Des Moines Marina Steps Bid Questions

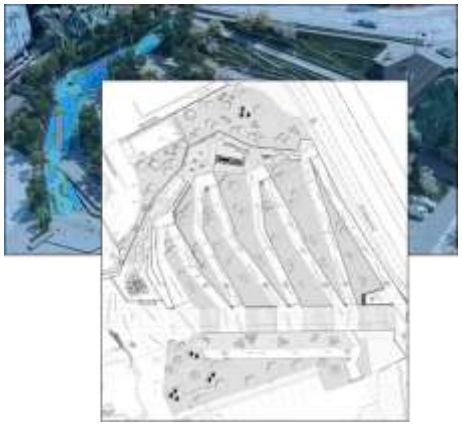
9	9/16/2025	please clarify if a weir wall is required here: 	No, there is only one weir wall by the overlook area along Cliff Ave. The Landscape Materials Plan Sheet L101 series will be revised with a following addendum.	Add. 1 9/26/2025
10	9/16/2025	C3.00 shows the existing catch basin and pipe to remain at new A-10 catch basin and along the blue pipe below. Please advise. 	Demolition Plan (Non-Surface) C3.00 and C3.00C will be updated to show removal of the existing 24-inch storm main to reflect the proposed extents of new pipe and catch basin on C7.00.	
11	9/25/2025	Please confirm if Builders Risk Insurance is to be provided by the City of Des Moines or included in Lump Sum Bid Price.	Builders Risk insurance will not be provided by the City. If needed, it should be contractor provided.	
12	9/17/2025	Is bypassing required for tie-ins to the sewer and storm systems? If so, please provide flow rates and upstream manhole and downstream manhole locations for pumping.	Bypassing is required. For storm, maintain a temporary, piped bypass for stormwater throughout construction duration in a responsible manner to protect adjacent properties. Assume 1.41± acres of tributary area to structure A-10. Assume 32.4 acres of tributary area to structure B-5. For sewer, assume as the worst case scenario the 8" pipe at full flow capacity of 2.98 cfs needs to be routed to the nearest downstream structure.	Add. 2 10/6/2025
